**The Ohio State University  
Nuclear Reactor Laboratory**

**RE: REQUEST FOR ADDITIONAL INFORMATION REGARDING THE OHIO STATE  
UNIVERSITY RESEARCH REACTOR APPLICATION FOR RE-LICENSING  
(TAC NO. MA7724)**

## **REQUESTED ADDITIONAL INFORMATION REGARDING THE OHIO STATE UNIVERSITY RESEARCH REACTOR (OSURR) - DOCKET NO. 50-150**

Figure 6.1: Administrative Organization

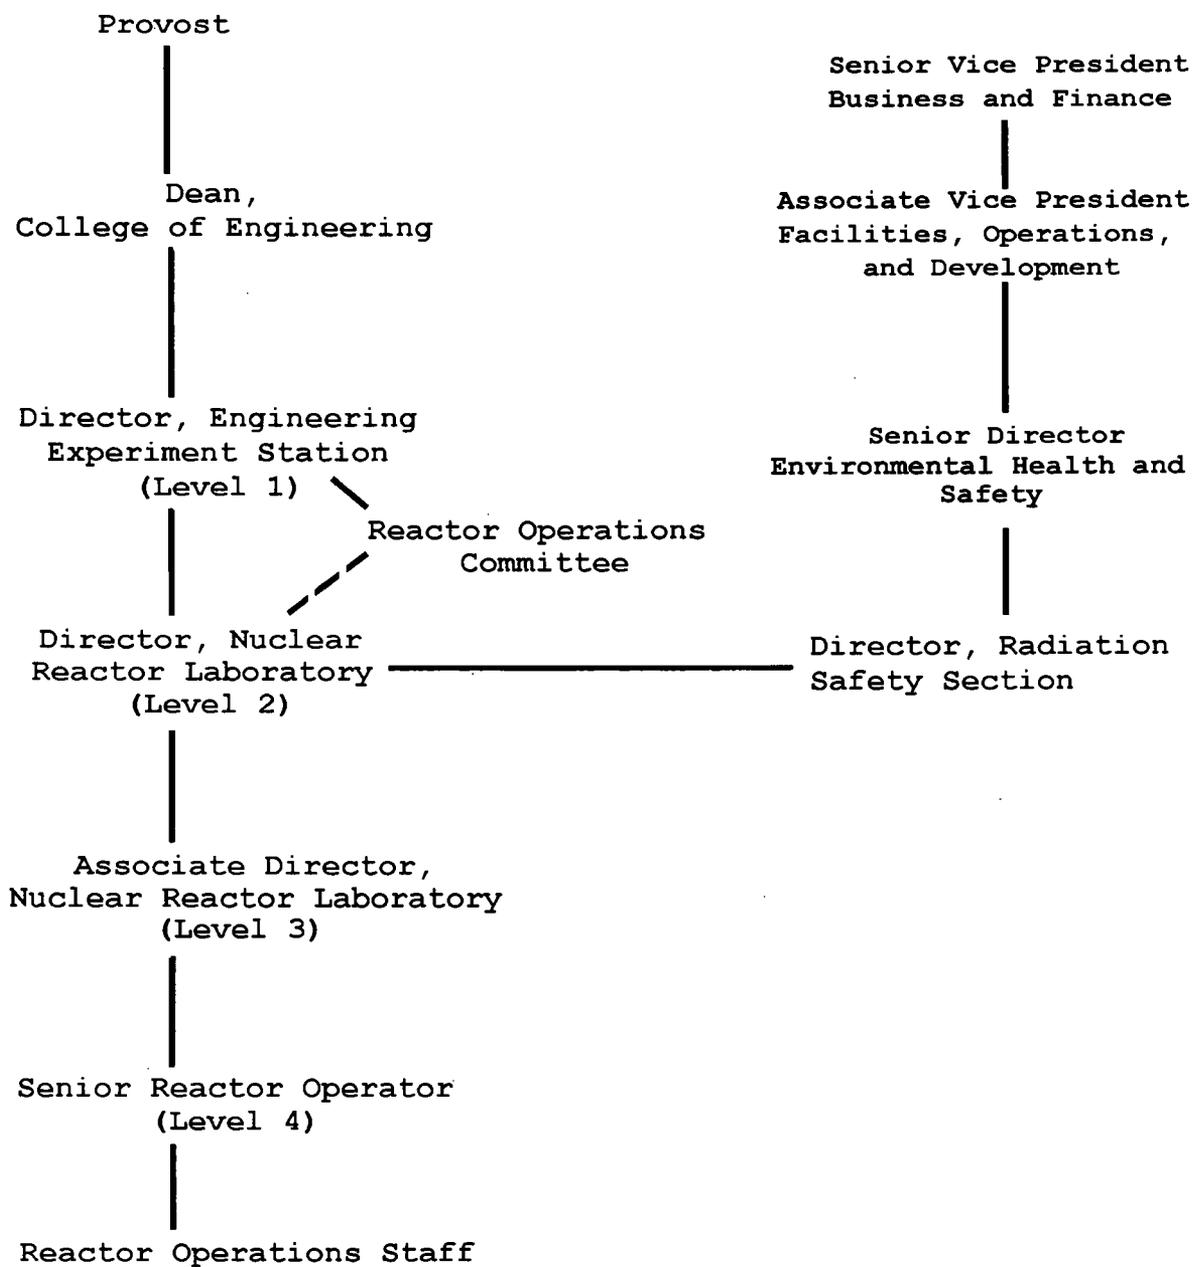
97. § 6.1 – Updated Figure 6.1 to reflect current administrative organization structure for the OSURR.
- Make TSs consistent with Amendment #18 to the Facility Operating License for the OSURR.

98. § 6.1 – Updated Figure 6.1 to reflect changes in Section 6.2 (ROC to report to Level 1 Management now)
- Align with ANSI/ANS-15.1-1990 recommendations

99. § 6.1 – Updated Figure 6.1 to reflect changes in position titles for those above the Director of the Radiation Safety Section. Paths of responsibility have not been changed, so therefore independence from OSURR management is not affected; only position titles have changed.
